PG&E Letter HIL-09-002

Materials License No. SNM-2514, Docket No. 72-27
Humboldt Bay Independent Spent Fuel Storage Installation

License Amendment Request 09-01
Revision to License Condition 14

**Chapter 17, Diablo Canyon Power Plant Units 1 and 2 Final Safety Analysis
Report Update (Current Revision – Marked-Up)**

FSAR UPDATE
UNITS 1 AND 2 DIABLO CANYON-
SITE HUMBOLDT BAY ISFSI
FIGURE 17.1-2
NUCLEAR QUALITY IN THE
UTILITY ORGANIZATION

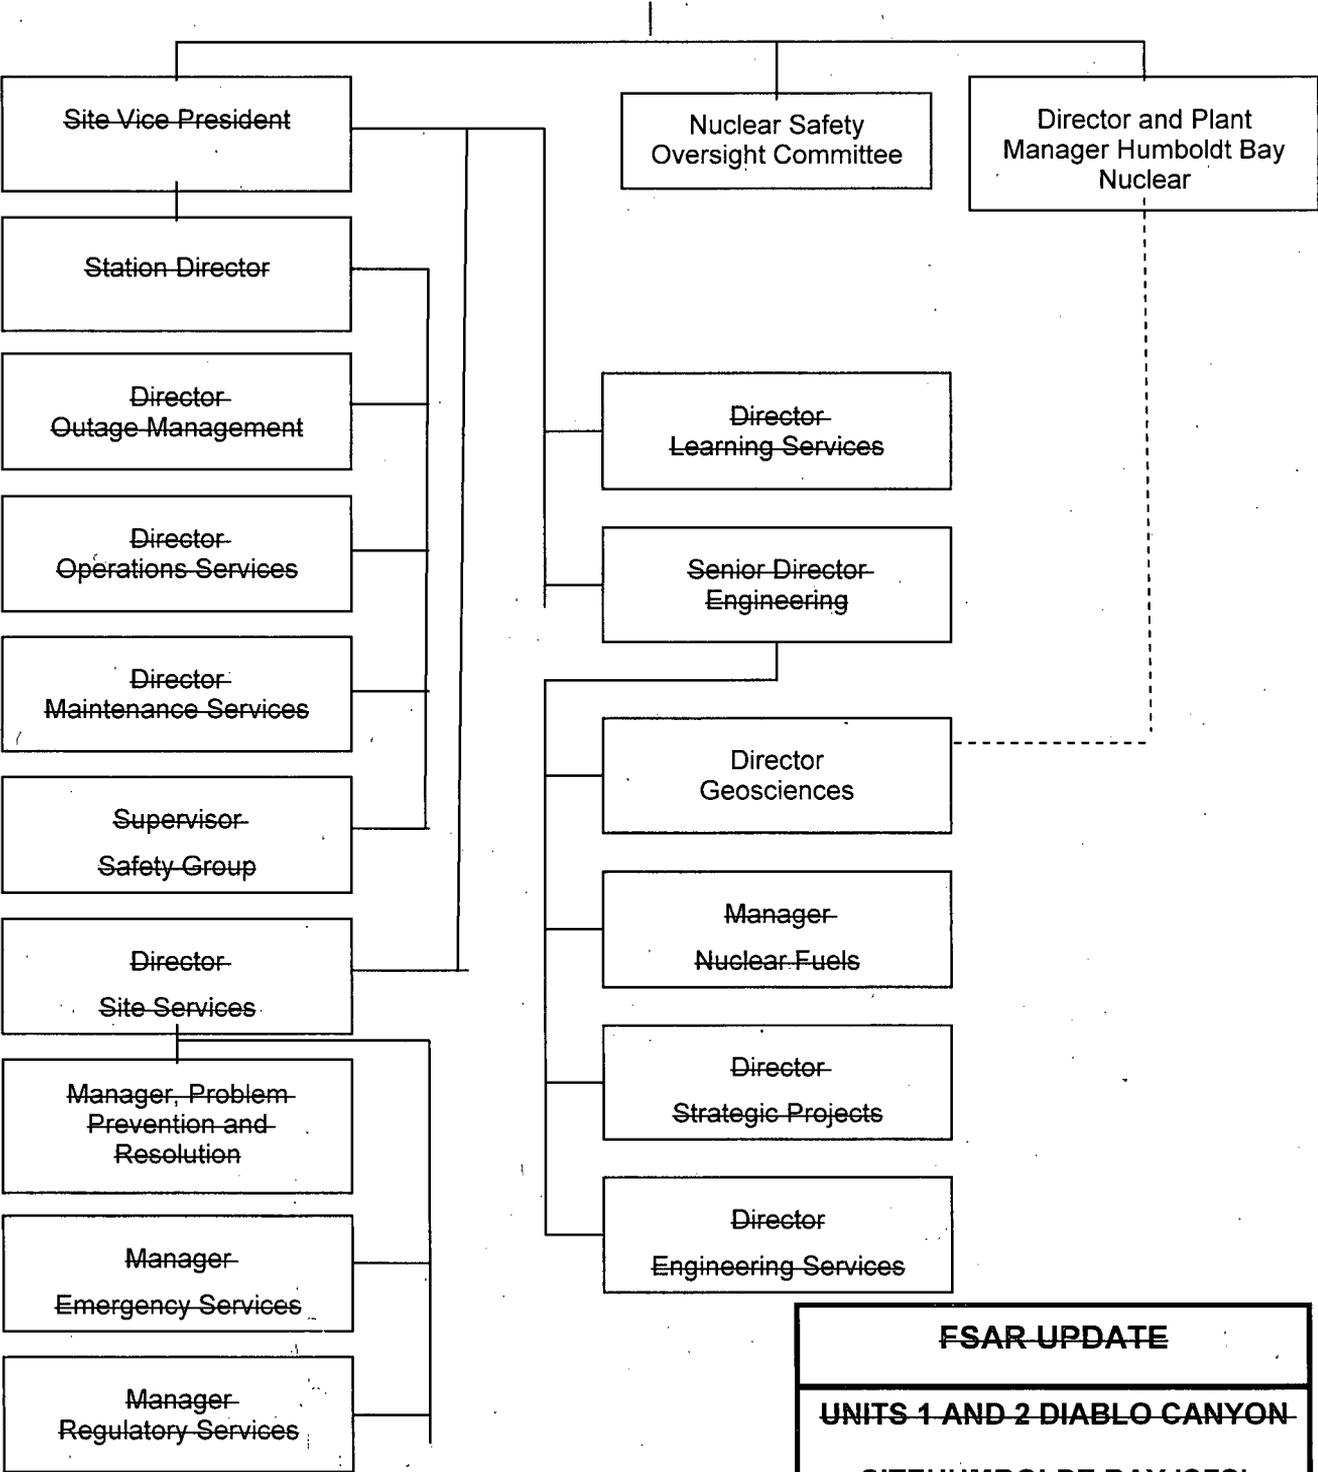
Figure 17.1-2 identifies those individuals and organizational components of PG&E with direct responsibilities related to the quality of the:

- ~~design, maintenance, and operation of DCP, and~~
- design, fabrication, construction, testing, operation, maintenance, modification, and decommissioning of ISFSI structures, systems, and components (SSCs) that are important to safety.
